# Wisconsin Department of Transportation

**Proposal #16: 6350-07-80**  
**Marshfield – Stevens Point**  
**WCL RR Pedestrian Underpass**  
**USH 10**  
**Wood County**

This is Addendum No. 02, which provides for the following:

**Addendum No. 02**  
**ID 6350-07-80**  
**Revised Sheet 6**  
**July 7, 2016**

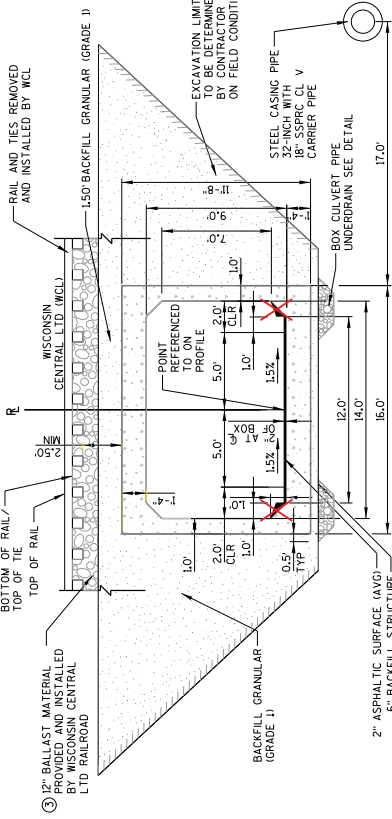
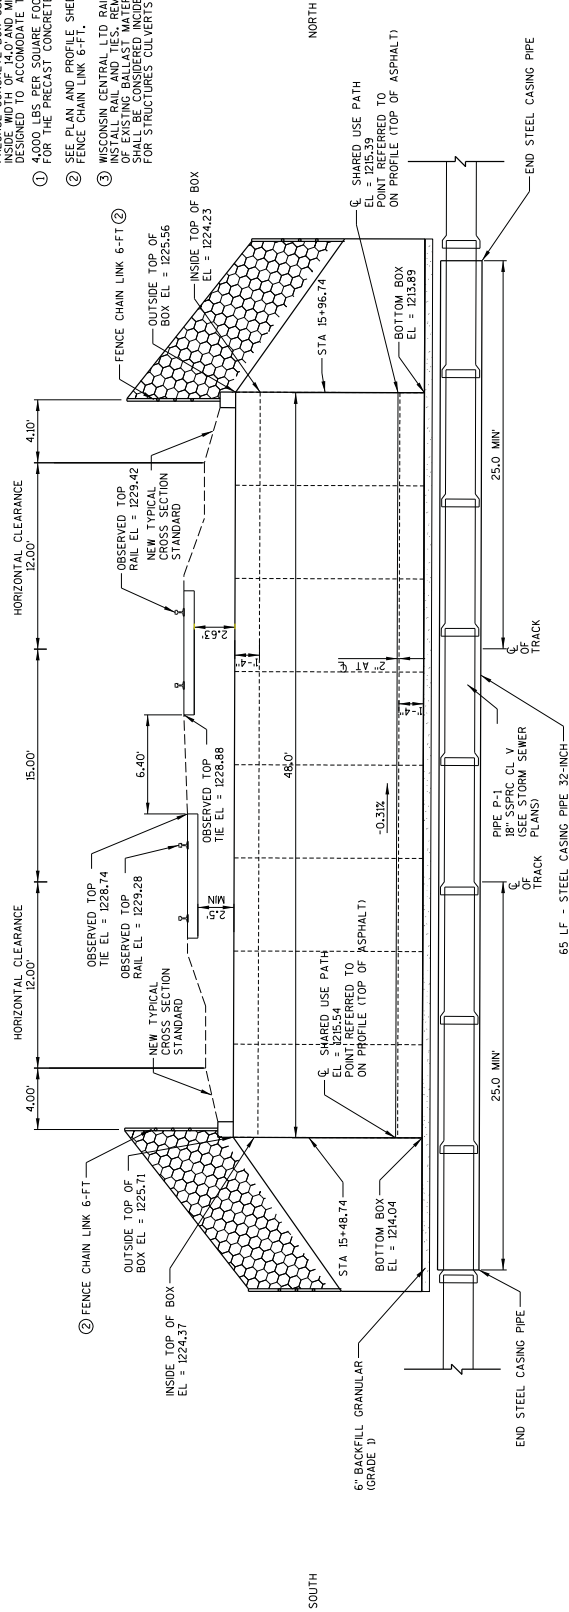
Revised Plan Sheets	
Plan Sheet	Plan Sheet Title (brief description of changes to sheet)
6	Typical Sections - Removed HMA curb from details and typical section.
